SUBJECT: Forwards application to amend License DPR-63.

Re: Niagara Mohawk Power Corporation
Nine Mile Point Nuclear Station,
Unit No. 1
Docket No. 50-220

APPLICATION FOR AMENDMENT

Proposed Changes To The Technical Specifications (Appendix A)

Figure 3.1.7.aa LIMITING POWER FLOW LINE

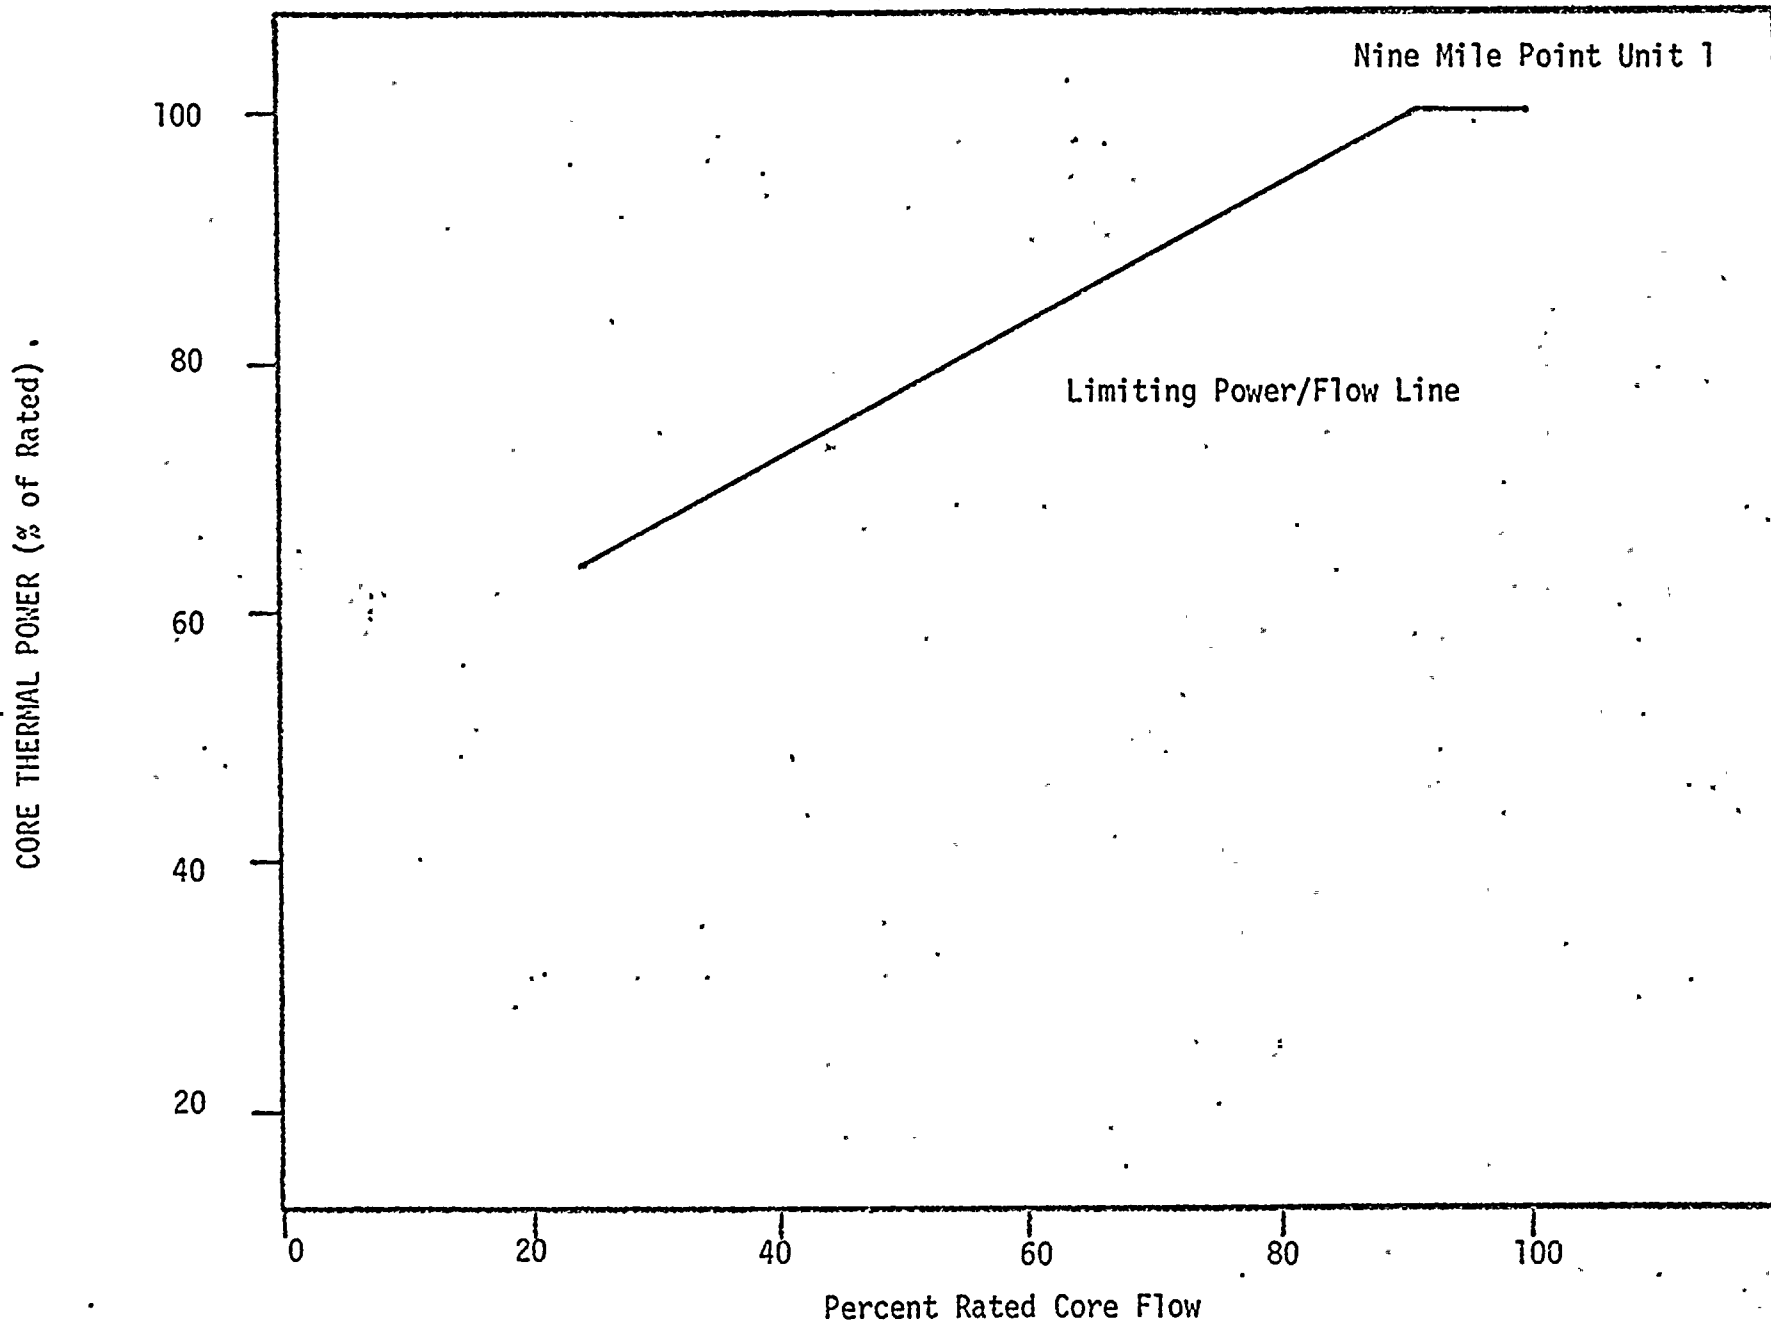
Pages 15 and 70a have been retyped in their entirety. Figure 3.1.7aa on Page 64c has been redrawn with changes shown.

The power/flow curve is the locus of critical power as a function of flow from which the occurrence of abnormal operating transients will yield results within defined plant safety limits. Each transient and postulated accident applicable to operation of the plant was analyzed along the power/flow line. The analysis (7,8,9) justifies the operating envelope bounded by the power/flow curve as long as other operating limits are satisfied. Operation under the power/flow line is designed to enable the direct ascension to full power within the design basis for the plant.
